MFN 06-494

Docket No. 52-010

Subject: **Response to Portion of NRC Request for Additional Information
Letter No. 62 Related to ESBWR Design Certification Application –
Tier 1 – Fire Protection – RAI Numbers 14.3-5 through 14.3-10, 14.3-
12, 14.3-13 and 14.3-16 through 14.3-21**

**Response to Portion of NRC Request for
Additional Information Letter No. 62
Related to ESBWR Design Certification Application
Tier 1 – Fire Protection
RAI Numbers 14.3-5 through 14.3-10, 14.3-12, 14.3-13
and 14.3-16 through 14.3-21**

Figure 2.16.3-1. Fire Protection System

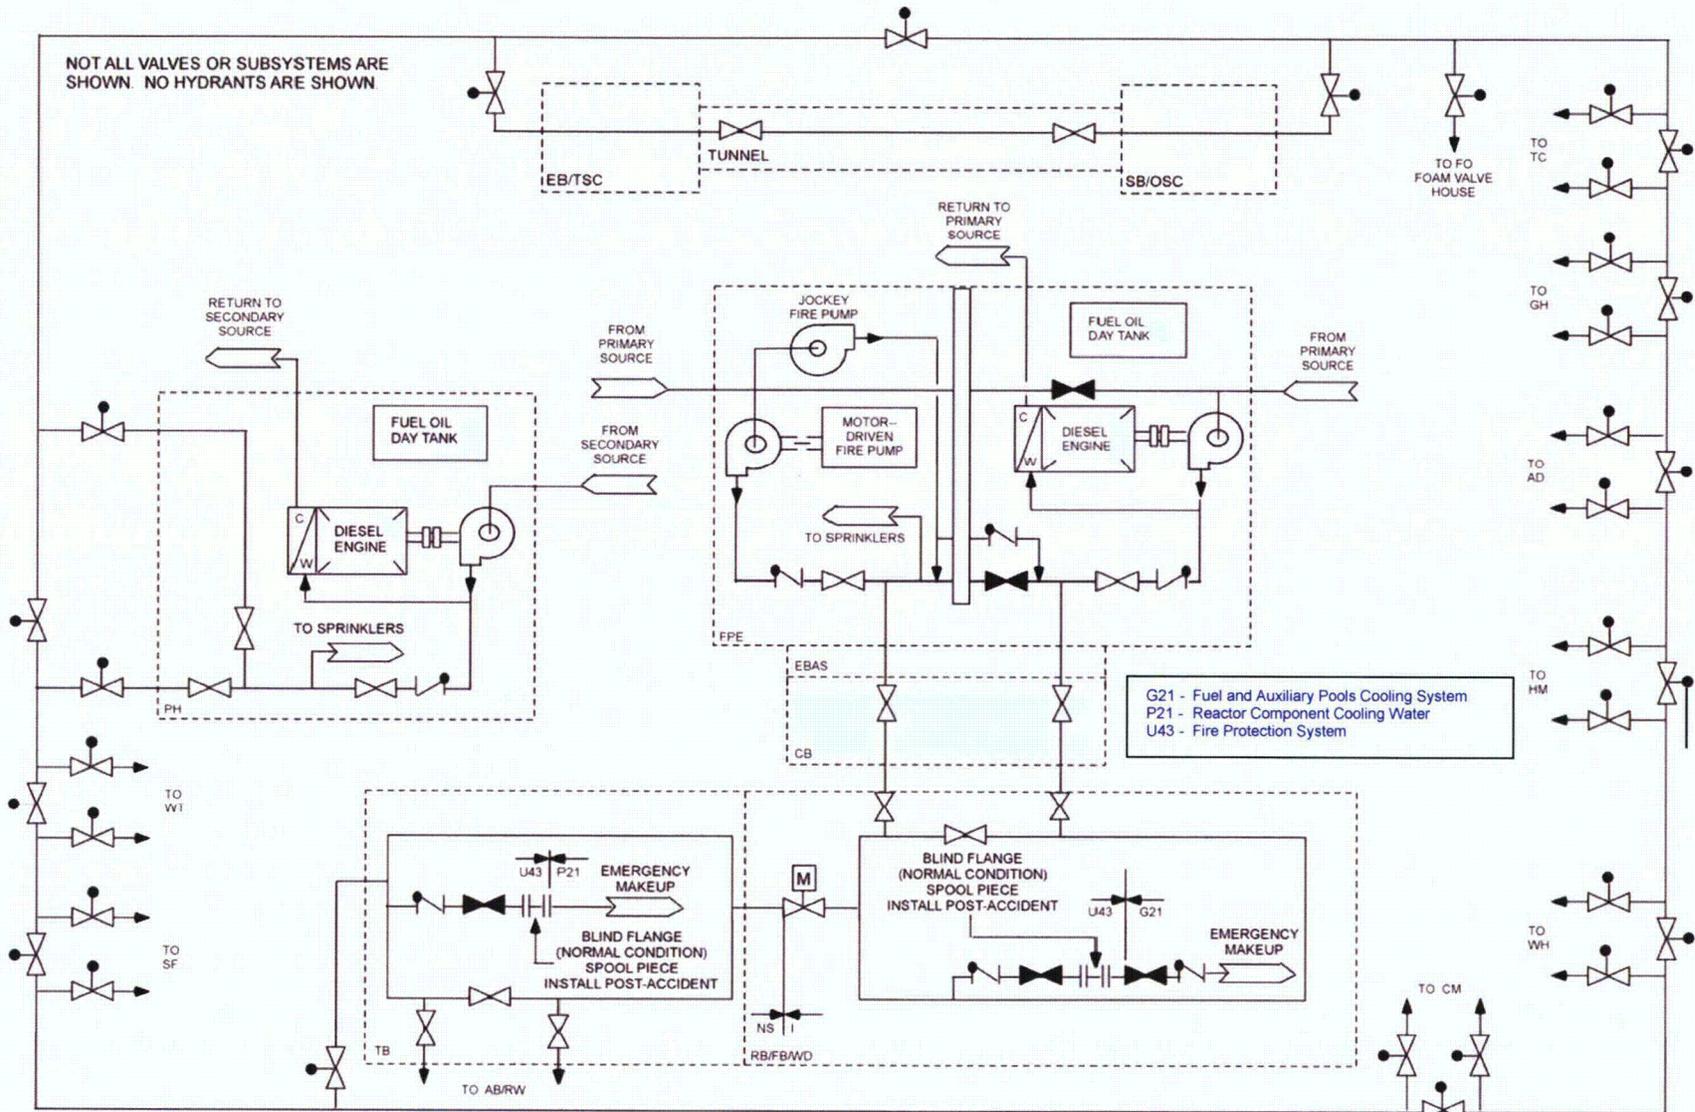
The fire protection system (FPS) interfaces for emergency makeup should identify the system to which emergency makeup is being provided. (DCD Tier 1, Figure 2.16.3-1)

DCD Tier 1, Figure 2.16.3-1 indicates two FPS interfaces as "Emergency Makeup". The figure should indicate the specific system to which each interface is providing emergency makeup. Update Figure 2.16.3-1.

DCD Tier 1, Figure 2.16.3-1 does indicate the specific system code that interfaces with the Fire Protection System (U43). The specific systems are Reactor Component Cooling Water (P21) and Fuel and Auxiliary Pools Cooling System (G21). These system identifications will be clarified on Figure 2.16.3-1.
